PURVIS OIL CORP

RE: Gladiola SWD Section 26 Release Site T-12-S R-37-E Section 26
Unit Letter J, NMOCD # 09-16-2366

Purvis Operating (Purvis) is submitting this modification to the September 25, 2009 investigation proposal for the above referenced site. Please note, Purvis has resigned as the operator of the Gladiola Salt Water Disposal System. The new operator will be contacting you to take over this project within the next few weeks

**RE: "Corrective Action Proposal"
for the Purvis Operating Company's
Gladiola NE Pipeline Release Site
Unit Letter O, Section 18, T12S, R38E, NMPM, Lea County, New Mexico
Remediation Plan (1R-498) Further Delineation Required**

Figure 4
Initial Investigation
Chloride Results
Gladiola SWD System
T-12-S, R-37-E, Sec 26 (J)
Lea County, New Mexico

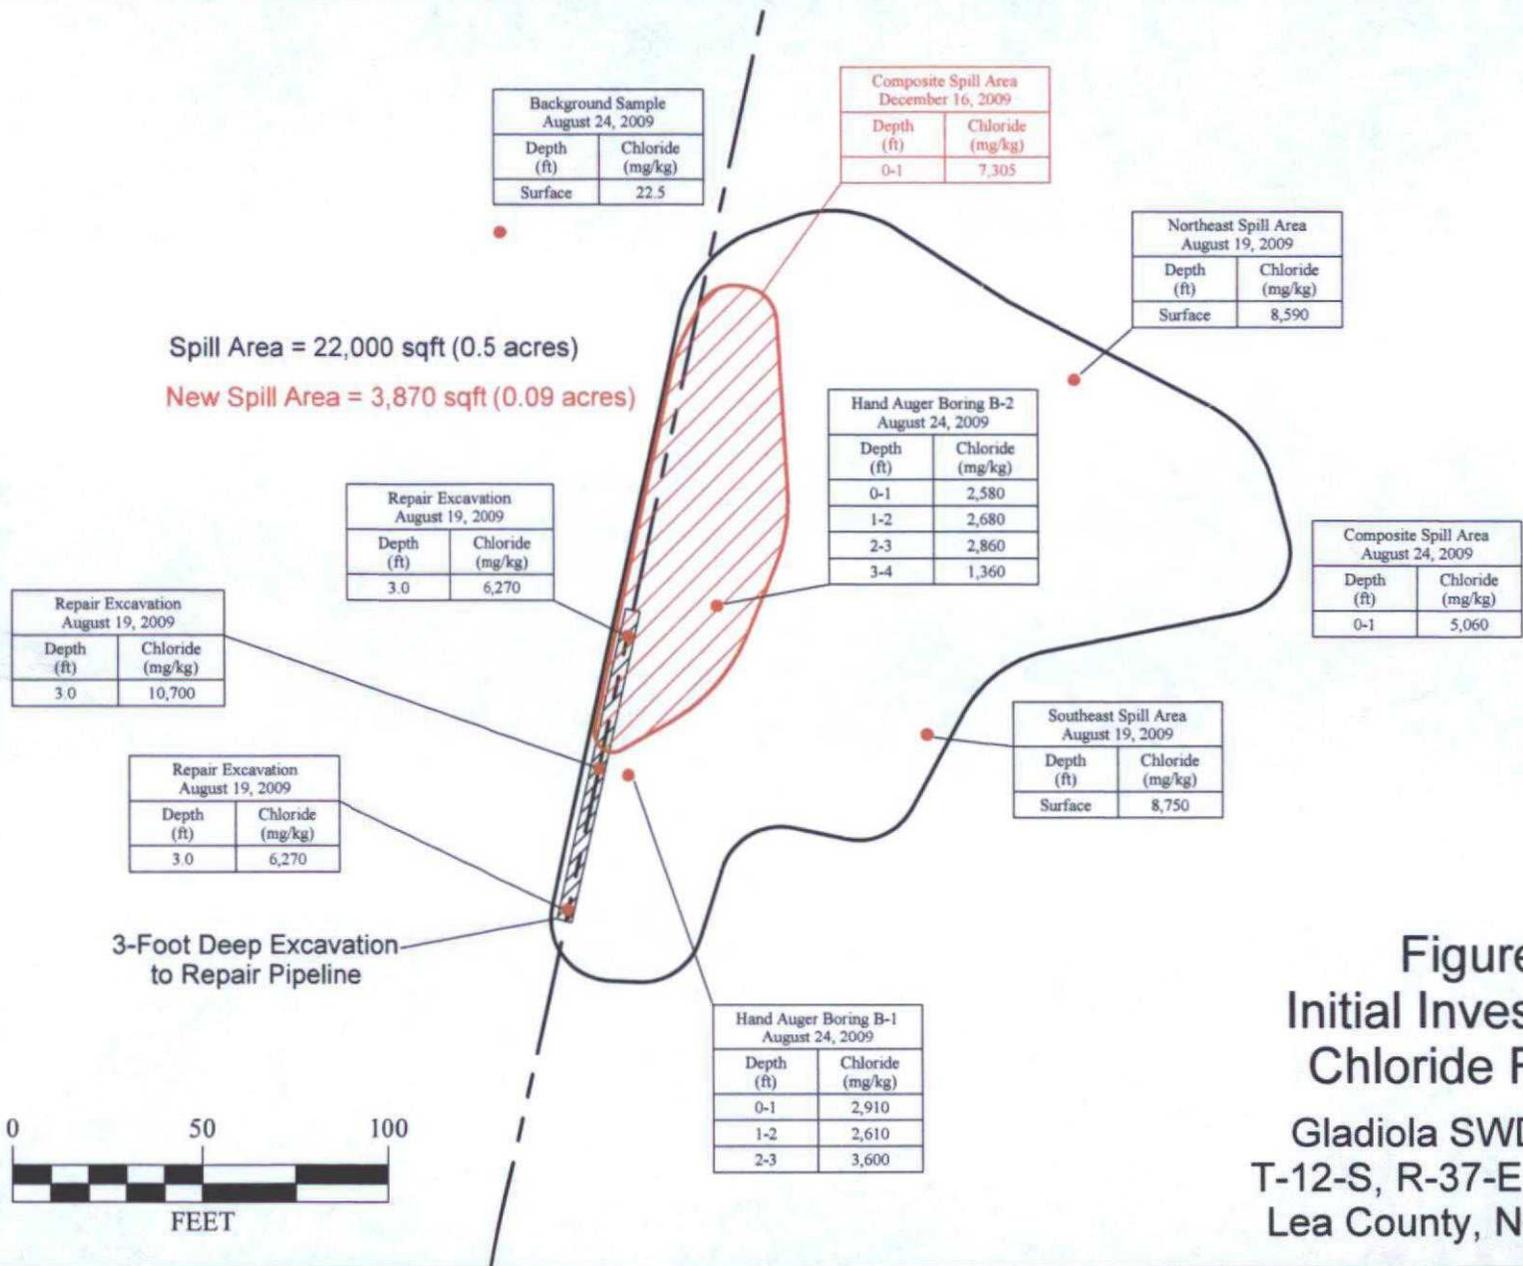
To augment existing data and to address the most recent release (see attached Plat), we propose the installation of up to five 4-inch monitoring wells and four additional soil borings at the locations shown. For borings and wells, soil samples will be recovered at 5-foot intervals with the first sample at 1-foot below ground surface. Samples will be field screened for hydrocarbon vapors (PID) and chloride (field titration). Laboratory analysis of TPH and BTEX will be performed on all soil samples that contain hydrocarbon concentrations of 100 ppm PID or more. Laboratory chloride analysis will be performed on a representative number of soil samples to verify the field screening results. All borings will reach a total depth of at least 16 feet or until

- 3 consecutive samples permit a determination that the vertical extent of impact is defined or
- The boring encounters saturated soil due to perched ground water.

If the borings encounter perched ground water, four perched zone 4-inch monitoring wells will be completed with five feet of PVC screen to a depth such that the confining layer underlying the "perched" ground water zone is not compromised. One 4-inch monitoring well, located to the southeast, will penetrate the regional aquifer and completion will follow state guidance with PVC screen placed about 5 feet above and 15 feet below the static water level. Field conditions may cause a slight variation of screen placement. A background monitoring well into the regional aquifer may be installed next to the perched zone background well if the field geologist determines that such a well is useful.
